**\*\*\* IMPORTANT SAFETY RECALL \*\*\***  
**NHTSA Recall No. 19E020**  
**Interim Recall Notice**

Cummins Inc. has decided that a defect which relates to motor vehicle safety exists in certain B6.7 diesel engines that were manufactured between December 16, 2015 and February 25, 2019 and equipped with fuel module option FS90301 or FS90453.

Figure 1 - Location of Fuel Filter Module & Heating Element

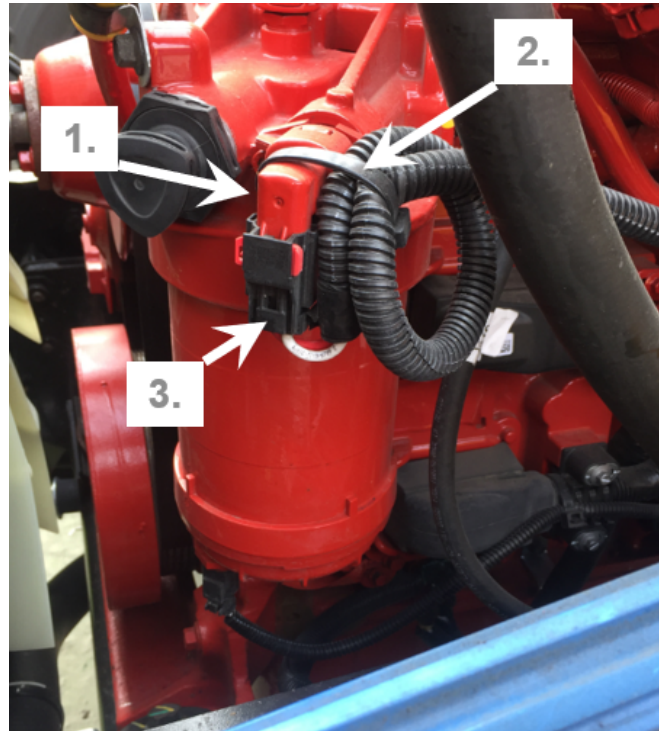
- Locate the fuel filter module and fuel heater at the driver's side front of the engine as shown in Figure 1 below.
- Inspect the heater and module for any signs of damage or fuel leakage.
- If there is no damage or leakage after engine shutdown, remove the fuel heater fuse as shown in Figures 2 or 3 below (based on application) and leave the wiring harness connected.
- In the event there are signs of damage OR leakage, contact your local Cummins service location at the number below to have a heater plug kit installed. (Reference TSB190038)

## Figure 2. Navistar® CE Bus Fuse Removal Instructions

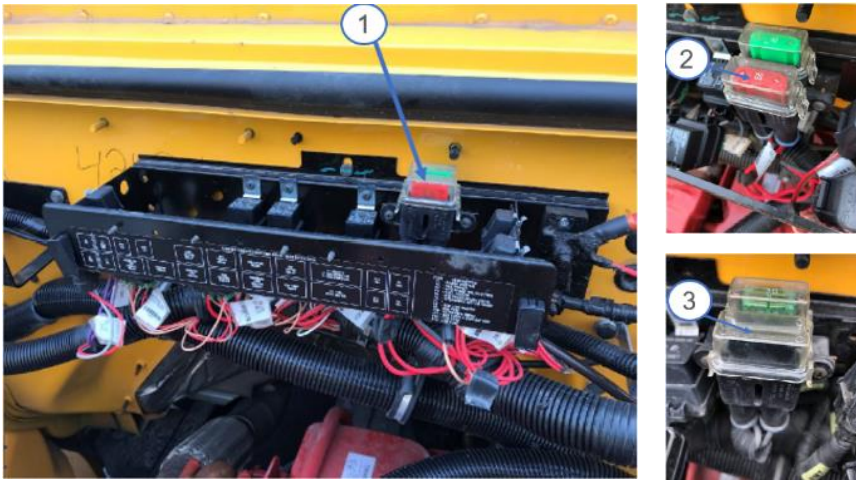
1. Locate red Maxi Fuse on dash panel. See Figure below.
2. Remove fuse cap and discard red Maxi Fuse. See Figure below.
3. Reinstall fuse cap. Do **not** replace fuse. See Figure below.
4. Retain fuse for reinstallation once final remedy is performed.

### Figure 3. Navistar® MV/HV Fuse Removal Instructions

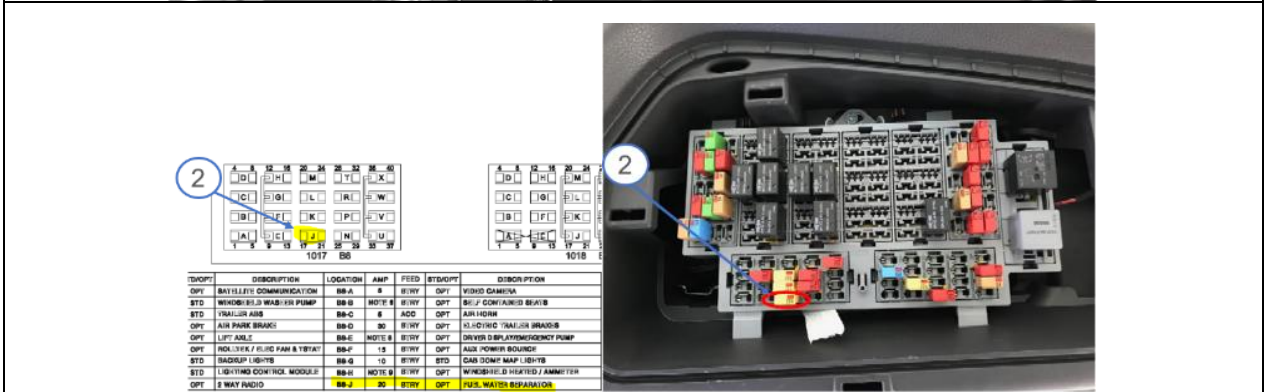
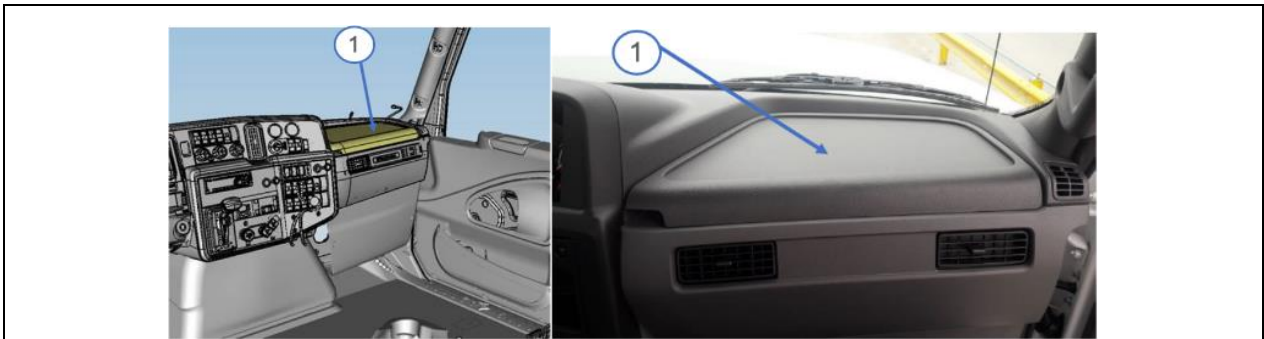
1. Remove cover of fuse box, located on passenger side dashboard as indicated in the photo below.
2. Remove 20 amp fuse located at B8-J cavity 17-21 as indicated in the photo below.
3. Remove 40 amp fuse located at 2C cavity as indicated in the photo below..
4. Retain fuses for reinstallation once final remedy is performed.
